## ARTICLE 300 — WIRING METHODS

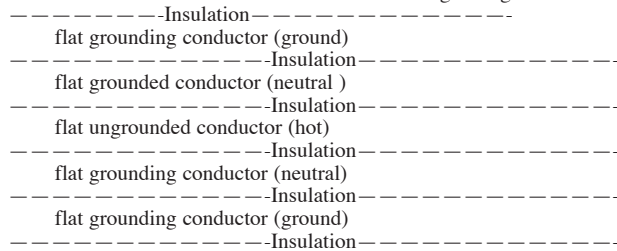
**Substantiation:** DeCorp Americas, Inc., has made dramatic improvements in AC FlatWire design since Proposal 7-30-(324) was submitted. The revised wire design is inherently safe when protected by a standard circuit breaker. Any puncture of the wire results in the circuit breaker tripping. This eliminates the need for an Active Safety Device (enhanced GFCI) as originally proposed.

The revised wire design is a multi-layer design> the design consists of layers of insulation and flat conductors with the following configuration:-----

Connector for the FlatWire tie the grounded (neutral) connectors together and tie the grounding (ground) connectors together at each end of a run of wire.
